ADDENDUM No. 1
Bid Package #1: Construction Documents
Encompass Architects, p.c.

Canopy Row
700 N St., Lincoln, NE 68508
NGC Group

EA Project No.: 16-1100

DATE OF ISSUANCE: February 8, 2017

4
A507 EXPANSION JOINTS- EXTERIOR
SCALE: 1 1/2" = 1'-0"

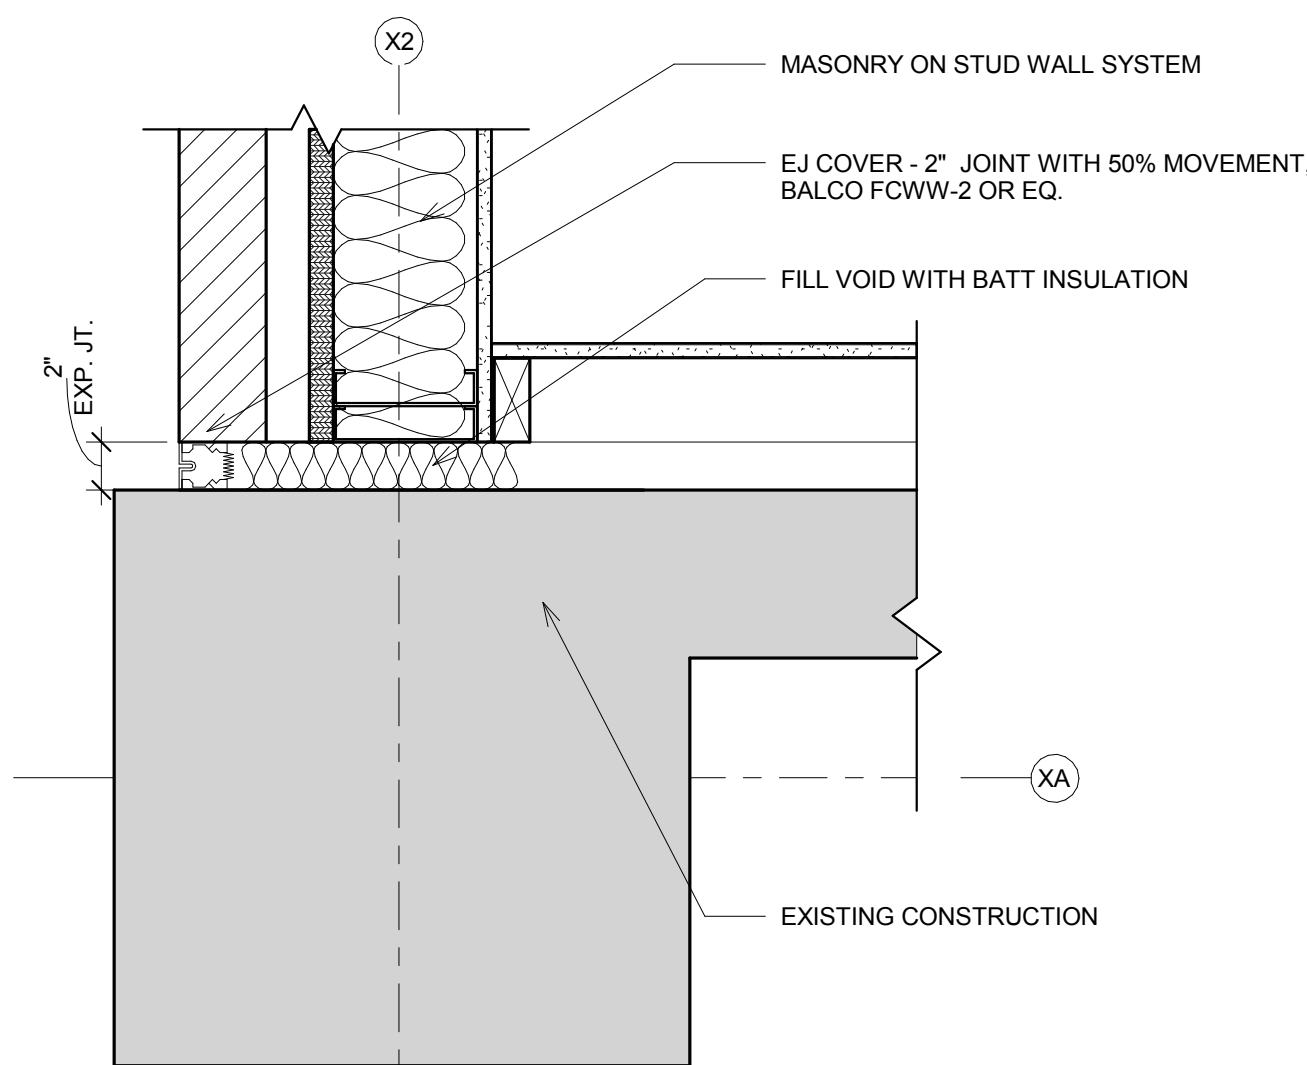
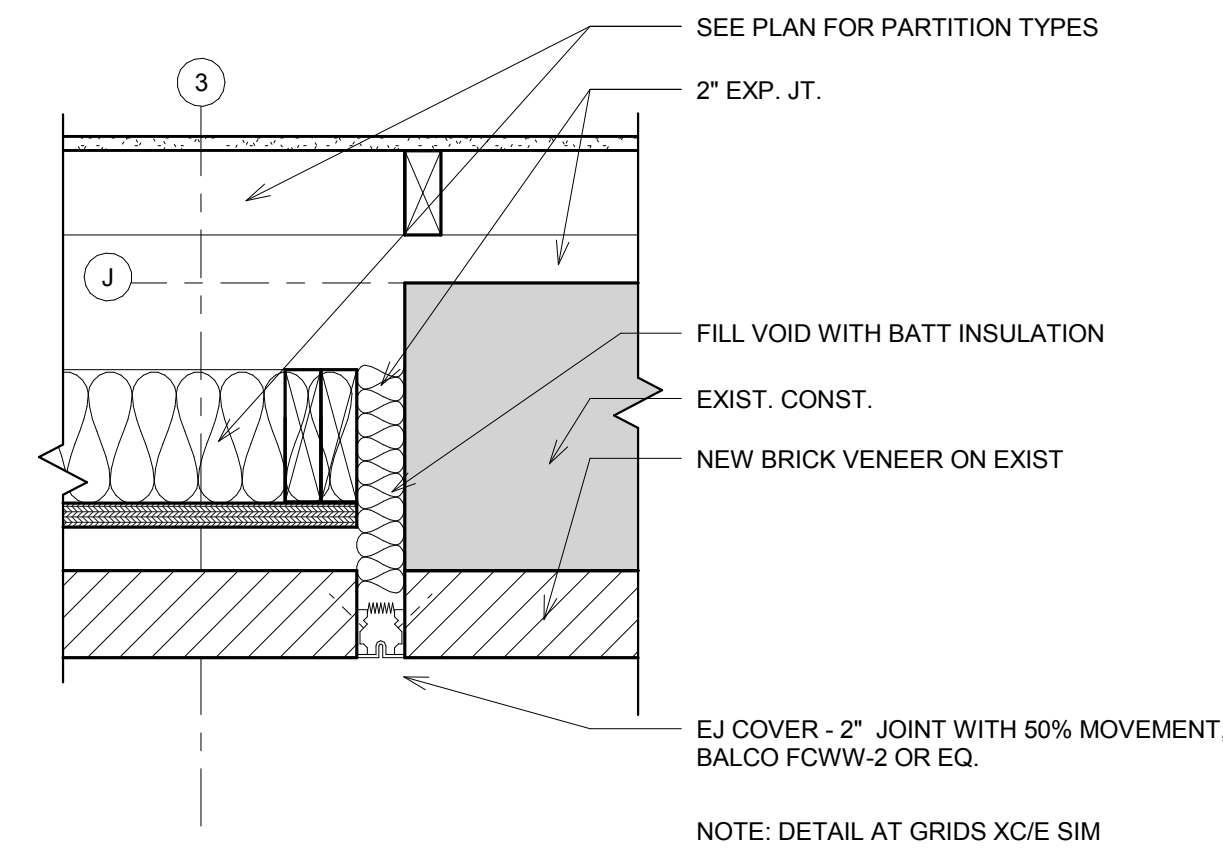
- Item AD-18. Sheet A507 – Wall Sections
- a. Add Detail 3/A507 Expansion Joints- Door and Detail 4/A507 Expansion Joints- Exterior
- Item AD-19. Sheet A512 – Details

4 ALUMINUM STOREFRONT FRAME TYPES
SCALE: 1/4" = 1'-0"

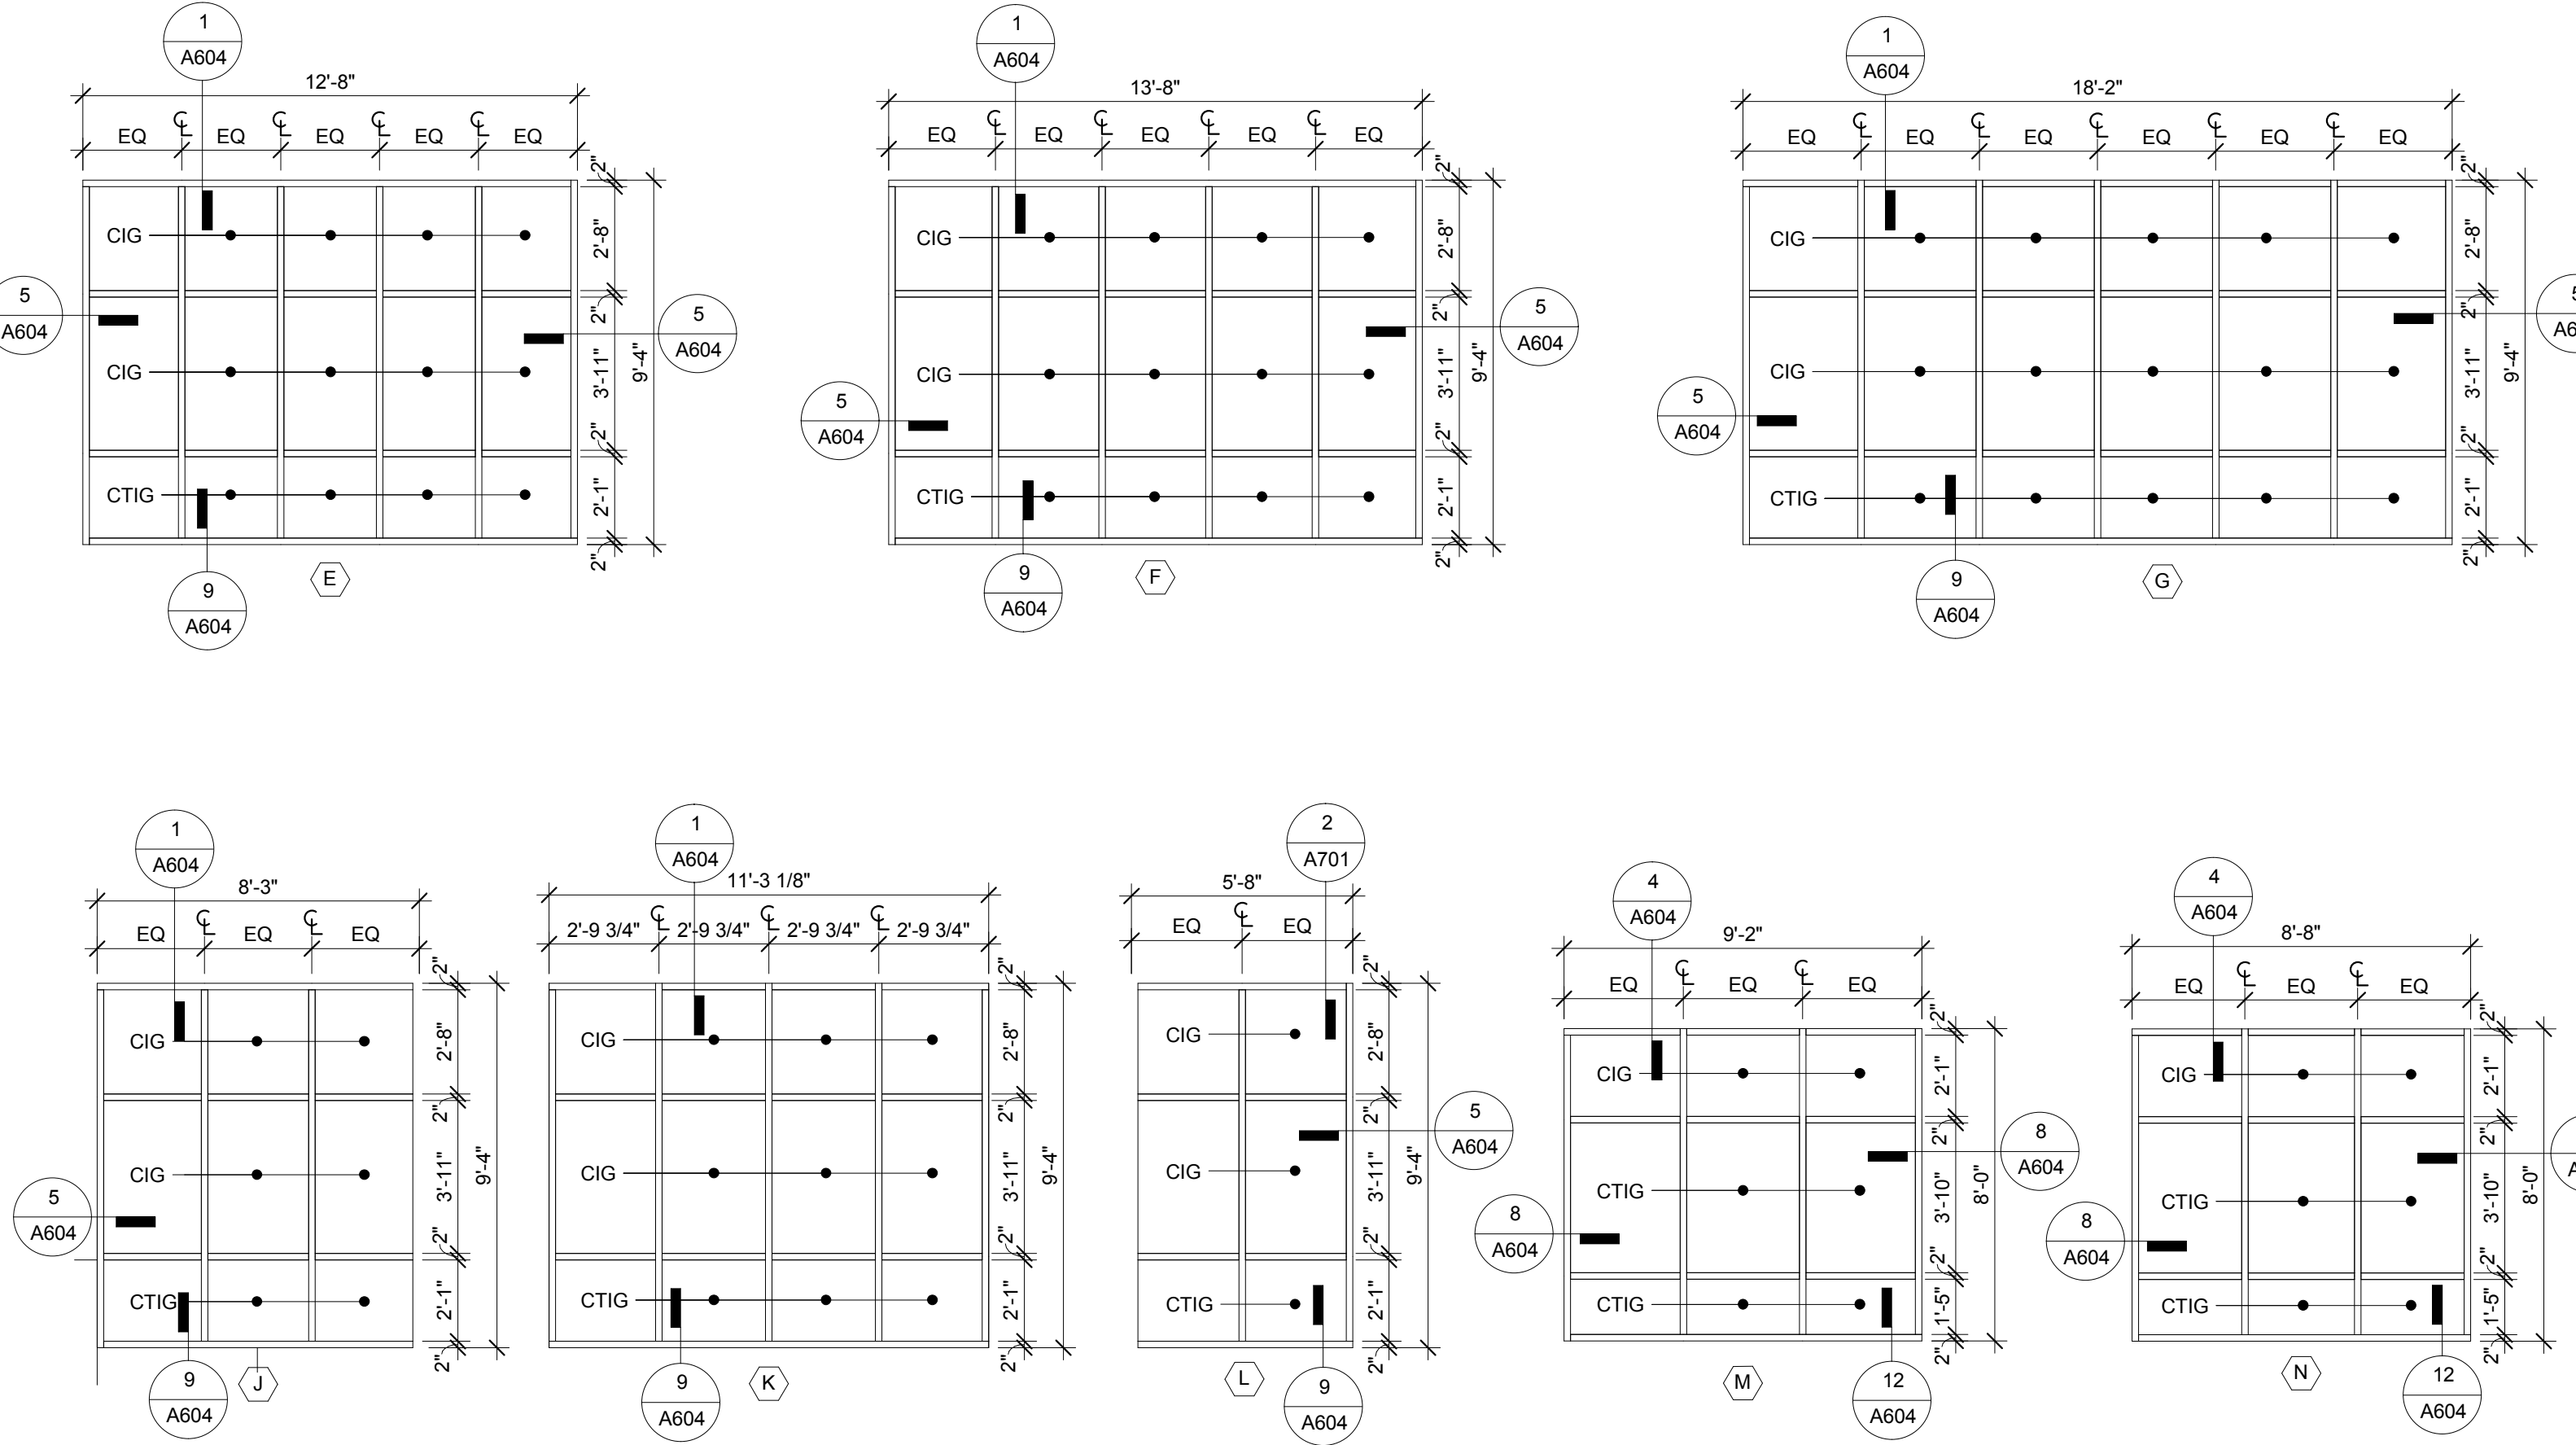
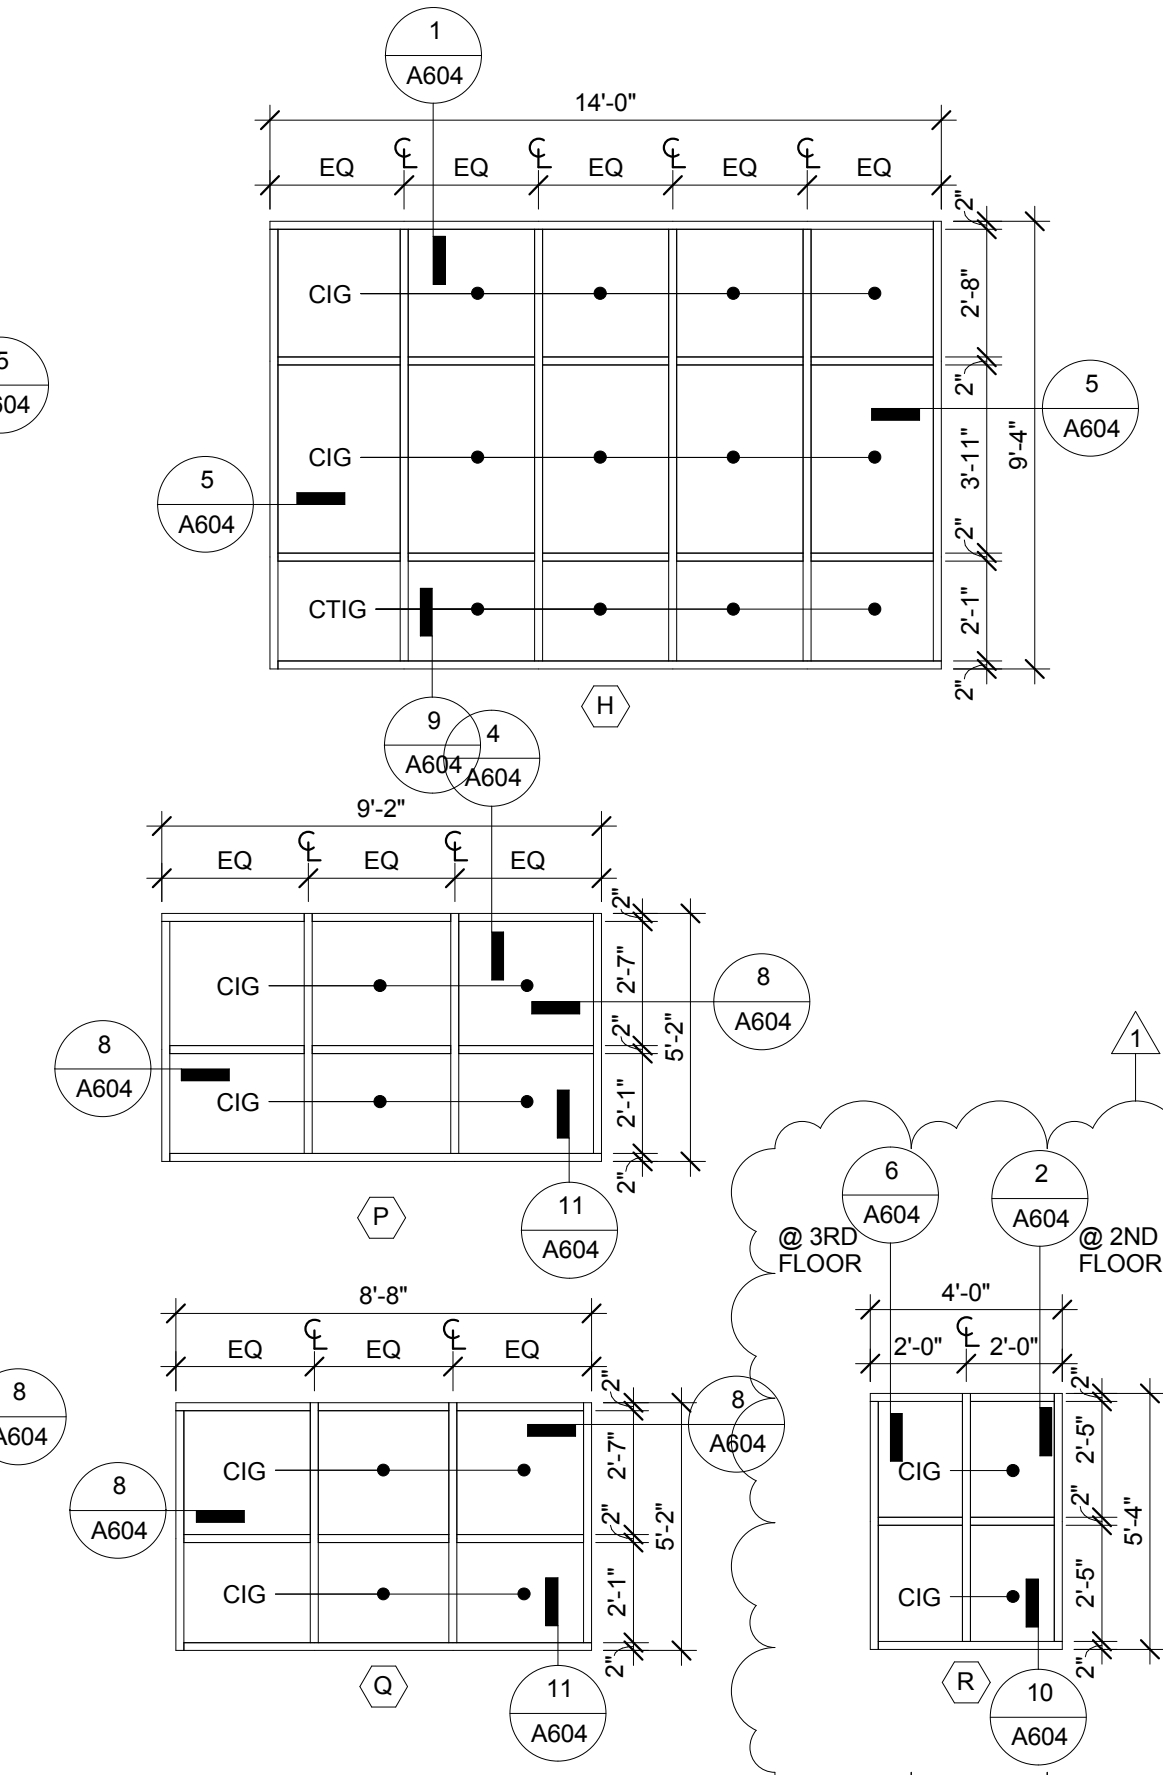
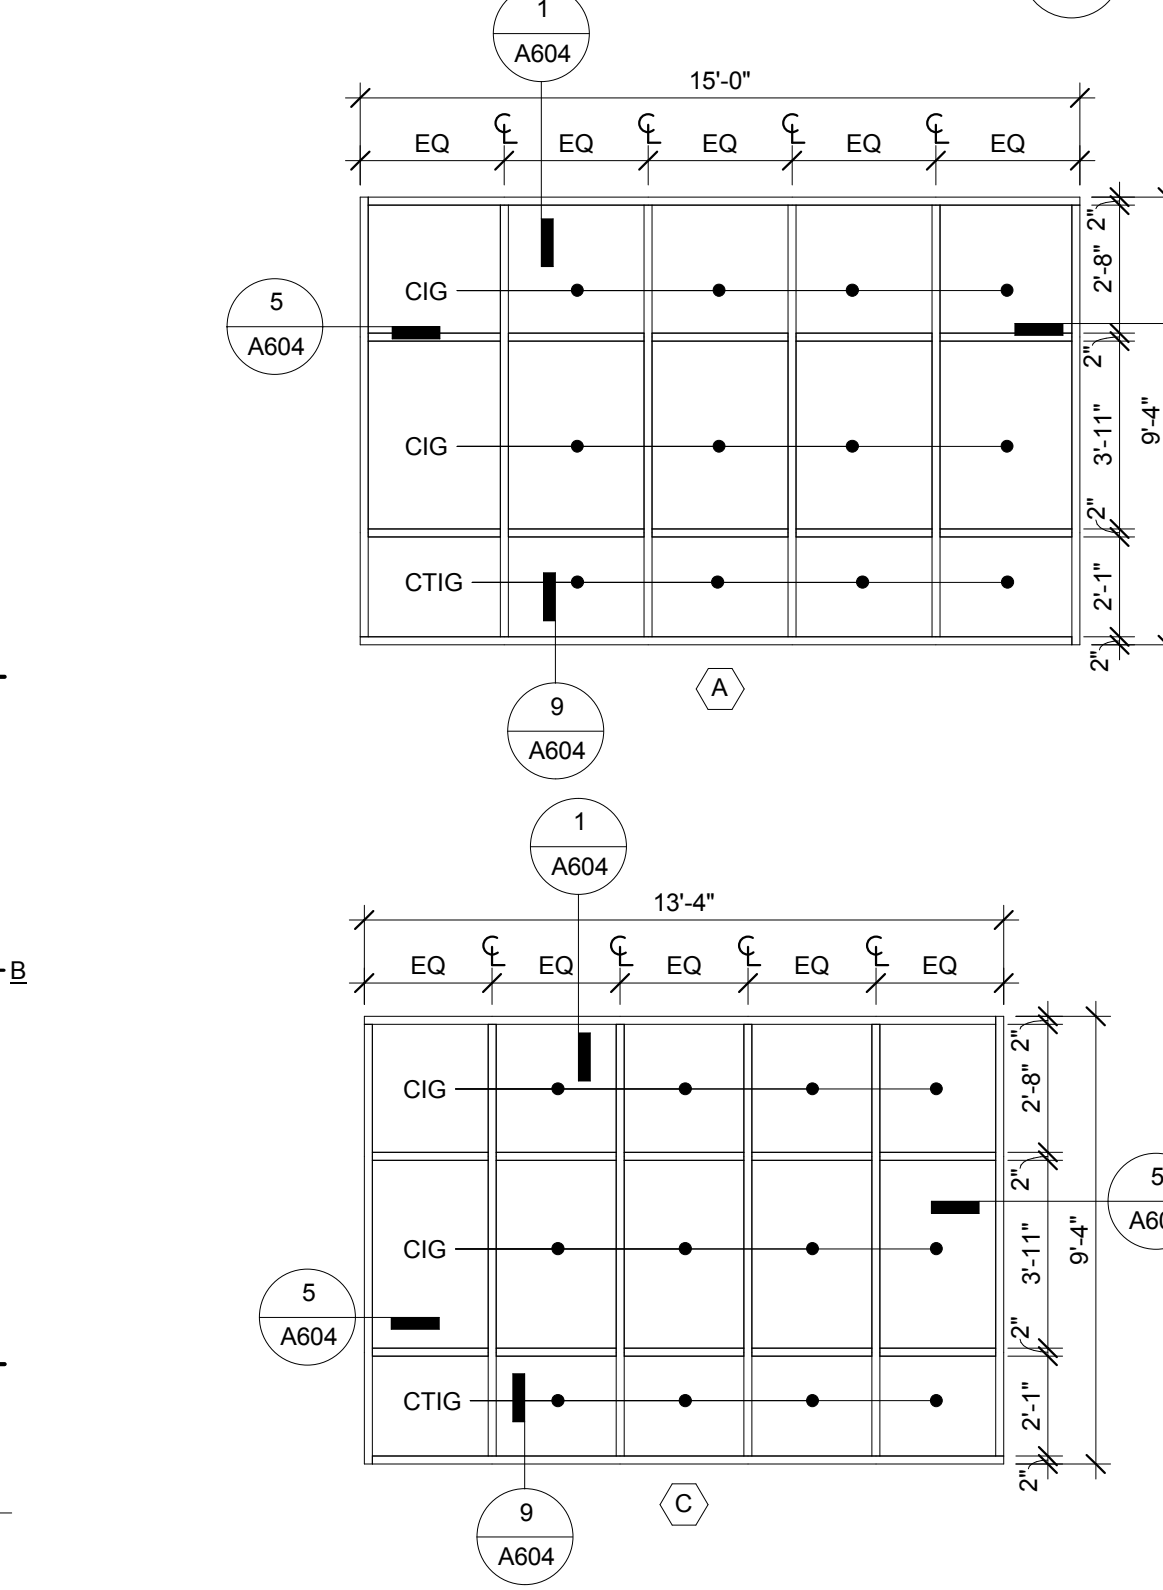
- c. Revise Aluminum Storefront Frame Type R, S1, and S2 as indicated on the attached sheet A601.
- Item AD-21. Sheet A602 – Doors and Windows
- a. Delete Door Thickness and Frame Depth columns from Door and Frame Schedule, typical. Refer to specification Division 08 for door thickness and frame depth.
